SCSU OLD STUDENT CENTER RENOVATIONS
SCHOOL OF BUSINESS

SOUTHERN CONNECTICUT STATE UNIVERSITY
501 CRESCENT STREET
NEW HAVEN, CT 06515

BID OPENING	**1:00 P.M.**	**AUGUST 4, 2010**
ADDENDUM NUMBER NO.1	**DATE OF ADDENDUM**	**JULY 26, 2010**

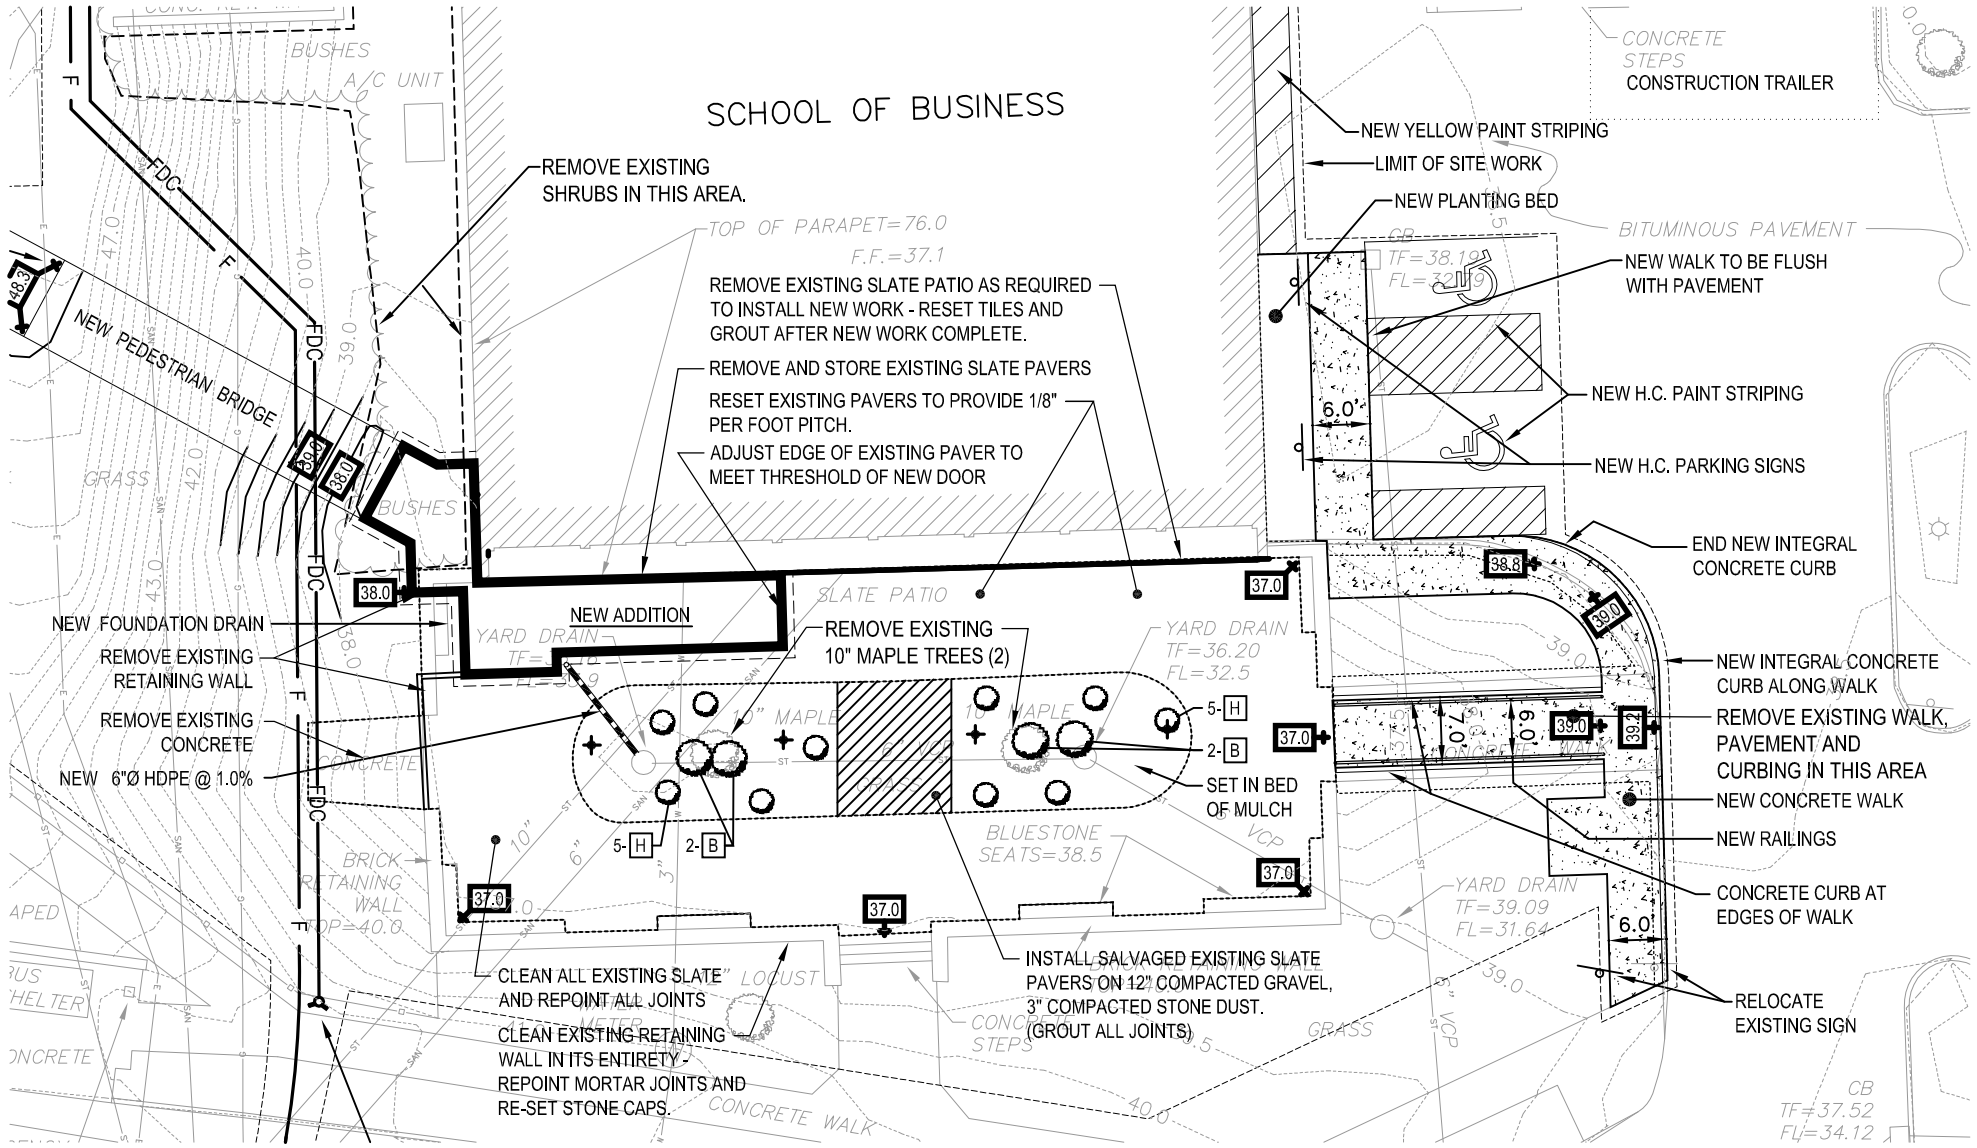
On drawing C.2 can you clarify what the scope of work looks like in the event Supplemental Bid #6 is not accepted? Do the trees remain in the center island area? Do we just patch to match the slate paving once the curtain wall and elevator additions are completed? Will there be any requirement to adjust the grades in the existing areas to meet correctly at the new entry doors? Etc.

All work is shown on SK-01 on the "Base Bid Grading, Utility, and Landscape Plan" dated July 26, 2010. The two 10" maple trees are to be removed in their entirety, patch and or reset slate patio tile as required. Remove and store existing slate pavers and substrate as required to install new wall, elevator, and entrance

vestibule. Repair slate patio at new to existing and install new slate infill from existing salvaged material. Remove and reset existing slate pavers to provide 1/8" per foot away from building perimeter entrance.

B10 WINDOW ELEVATIONS
1/4" = 1'-0"

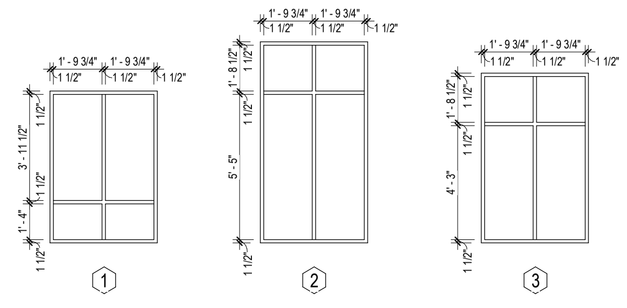
On drawings A8.101 there are a number of window types and elevations indicated on the upper left part of the sheet. There are no sections cut through these windows. Can you please confirm if these are hollow metal frames or aluminum storefront materials?

Drawing A8.101 makes reference to clear glass with blinds at interior frame types B7, B8, C8 and C10. Is this 1/4" glass with blinds by others or a unit with two lites of glass with internal blinds. If so please provide a spec.

On drawing A8.101, "Door & Frame Schedule", dated 2/24/2010, Elevations B10, B8, B7, C10, C8 and all items shown on G10 are hollow metal frames (welded frames).

All interior hollow metal frames shown on Drawings A8.101 "Door and Frame Schedule" shall receive surface mounted Horizontal Louver Blinds fastened to head of frame. Frames to receive blinds include those shown on B10, B8, B7, C10, C8, and G10 shown on drawing A8.101 "Door and Frame Schedule" dated 2/24/2010. Refer to specification section 12-21-13 Horizontal Louver Blinds.

E10 DOOR PANEL ELEVATIONS
1/4" = 1'-0"

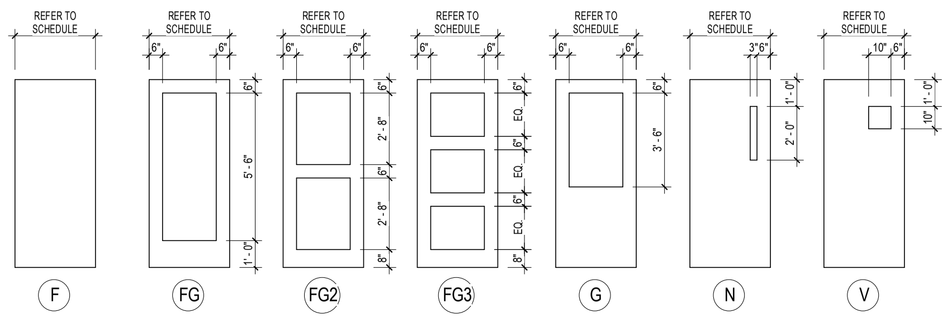
What type of glazing goes into the door panels per Detail E10 on A8.101?

Refer to specification section 08-80-00 GLAZING PART 2 PRODUCTS, 2.01 GLAZING TYPES, D. Type S-2 – Fire Rated Safety Glazing or Type S-3 – Single Safety Glazing: Non fire rated.

G10 DOOR AND FRAME ELEVATIONS
1/4" = 1'-0"

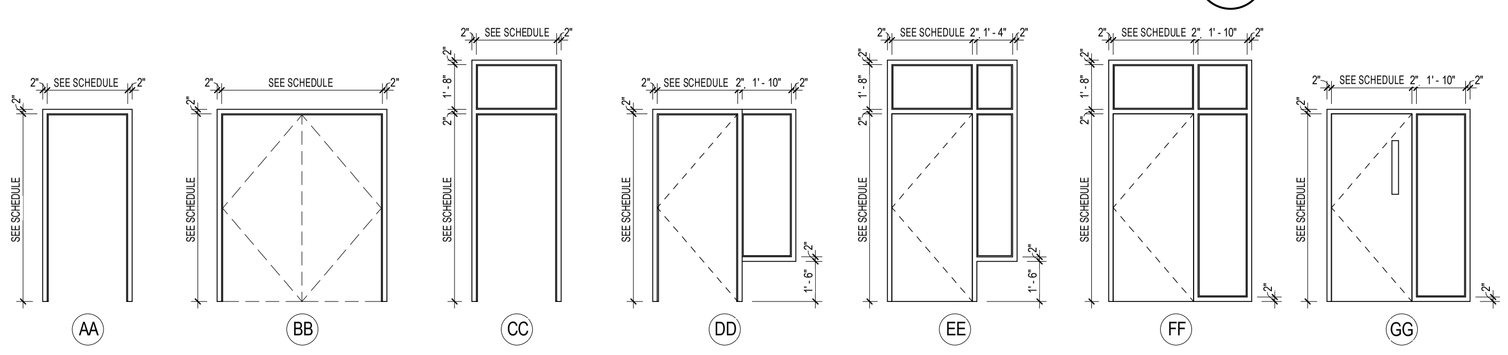
What type of glazing is used at the transoms and sidelights of door frames, as shown in Detail G10 on A8.101?

Drawing Title: ROOF PLAN

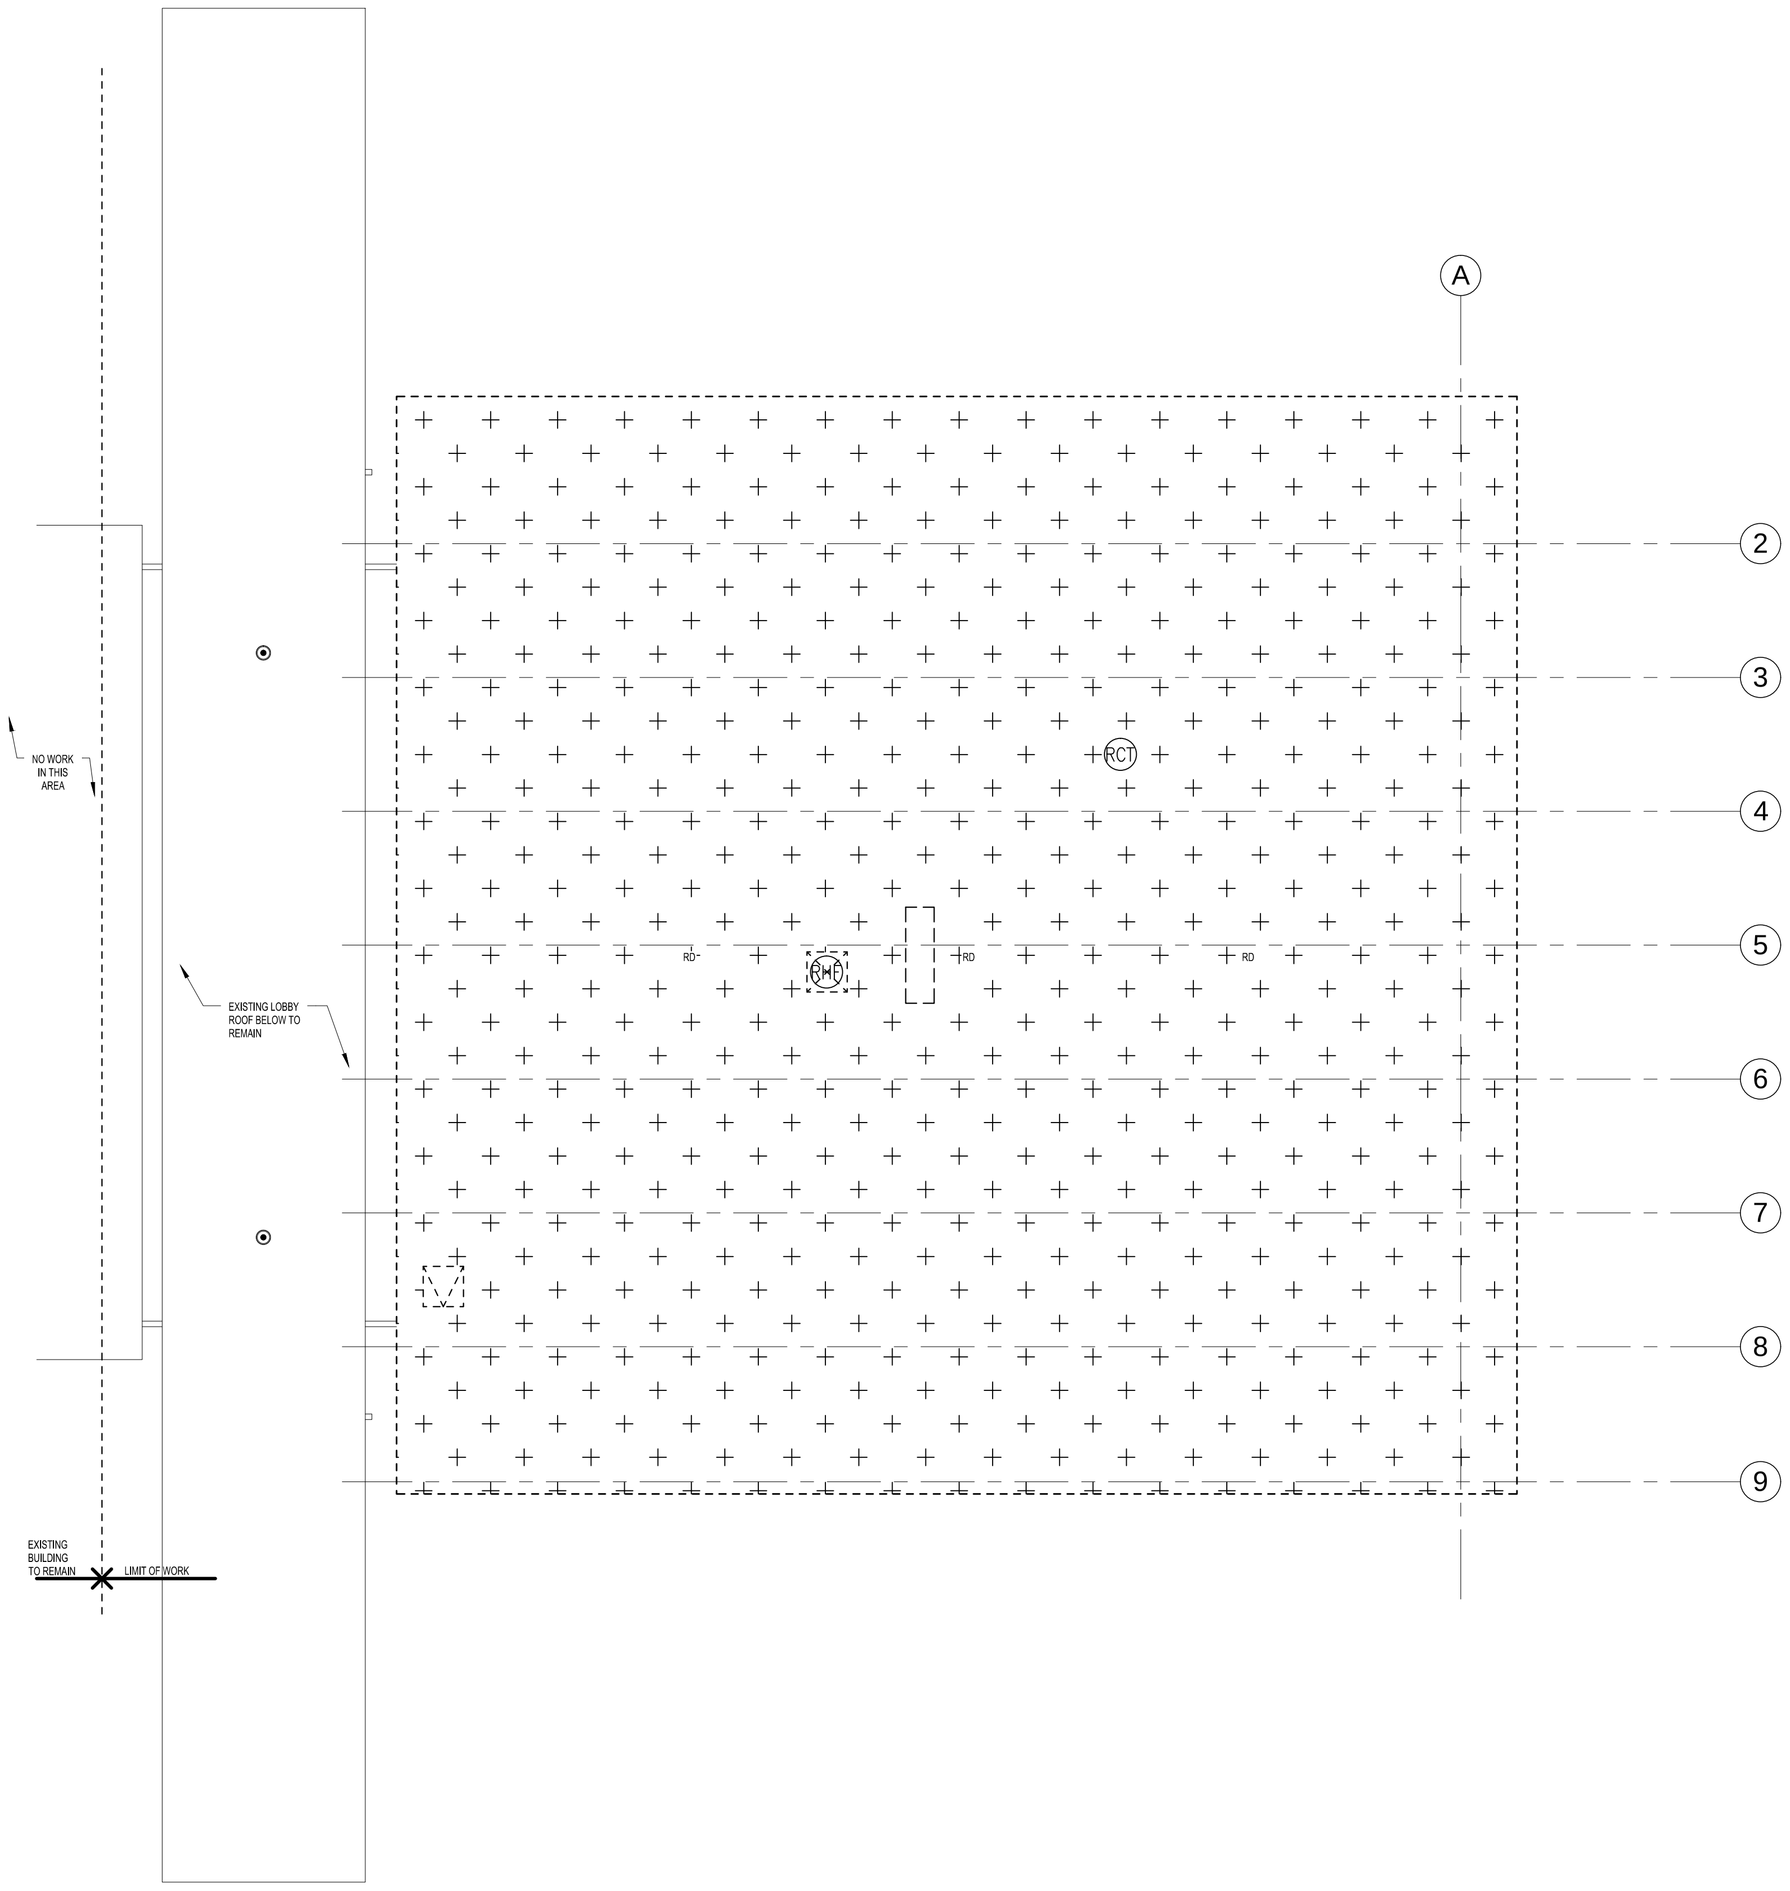
The following items have been added to the scope of work:

3. All work described on Drawing: SK-1 "Roof Plan", dated 12/25/2009, from ATC Associates Inc. (Project Number RS-09-05)
